# CITY OF ALBUQUERQUE

RE: **6212 Tesuque NW**  
**Pad Certification for lot 4 Block 8A**  
**Engineers Stamp Date 9/5/18 (E10D049)**  
**Certification Date 9/5/18**

## DRAINAGE AND TRANSPORTATION INFORMATION SHEET (REV 6/2018)

ENGINEER'S SEAL	LOT 4, BLK 8-A U 3 VOLCANO CLIFFS 6210 TESUQUE DRIVE	DRAWN BY DEM
DAVID SOULE REGISTERED PROFESSIONAL ENGINEER 14522	GRADING AND DRAINAGE PLAN	DATE 8-7-18
9/5/18	 1606 CENTRAL AVENUE SE SUITE 201 ALBUQUERQUE, NM 87106 (505) 872-0999	LOT 4 BLOCK 8A (RM) DWG
DAVID SOULE P.E. #14522		SHEET # C1
		JOB #

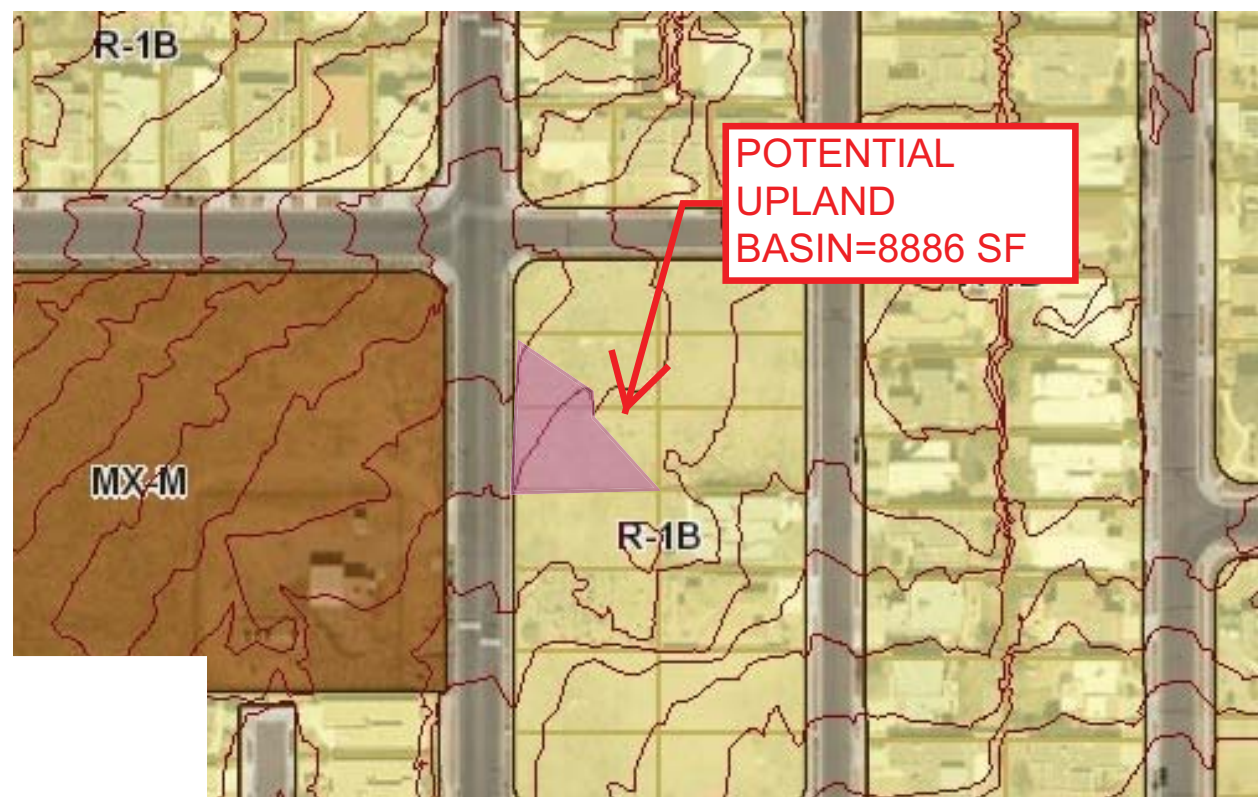
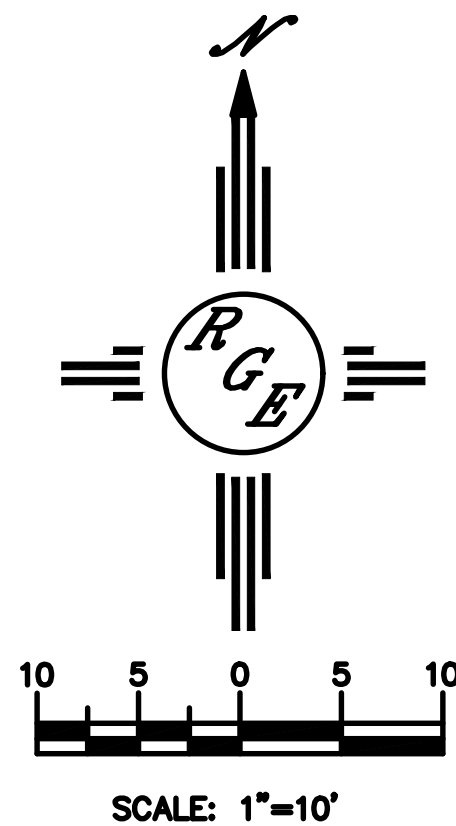
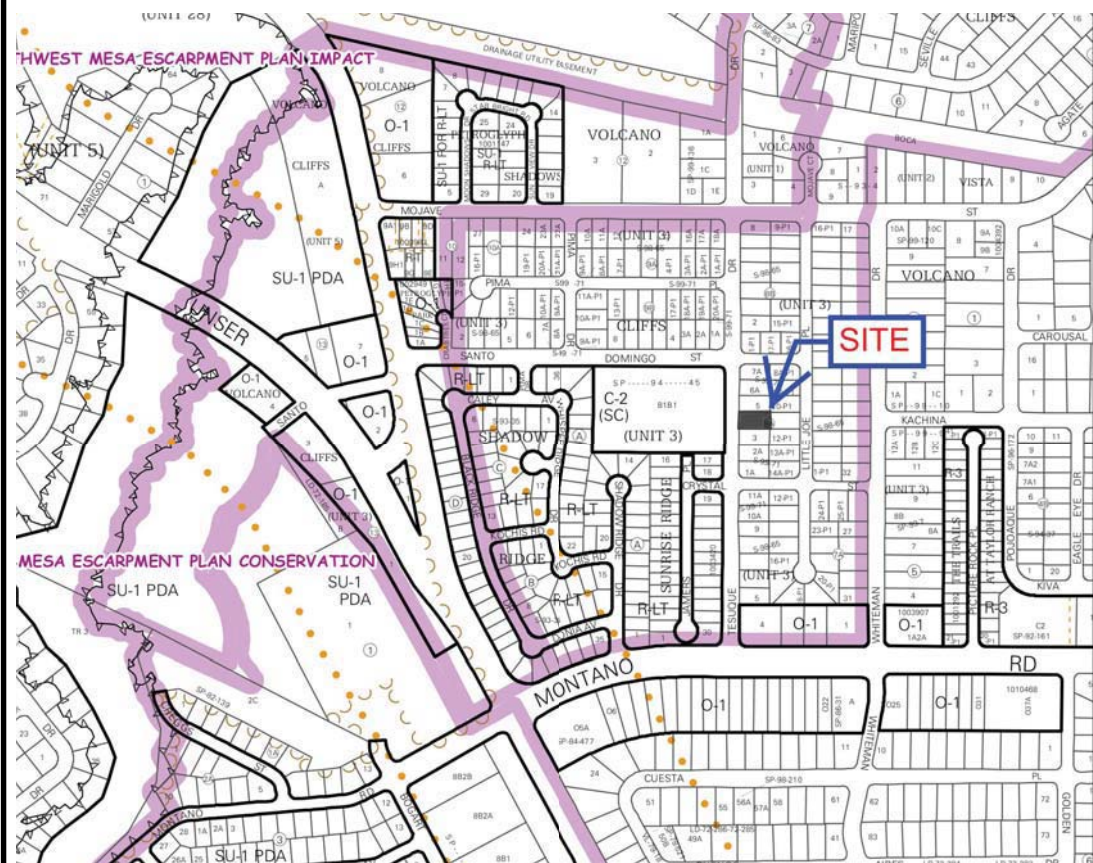
Based upon the information provided in your submittal received 9/11/2018, the above referenced Pad Certification is acceptable for building permit.

Please inform the builder/owner to attach a copy of this approved plan and letter to the construction sets in the permitting process prior to sign-off by Hydrology.

Reiterate to the Owner/Contractor that a separate permit for a garden/retaining wall must be obtained with the approved G&D plan and Pad Certification.

Prior to Certificate of Occupancy release, Engineer Certification per the DPM checklist is required.
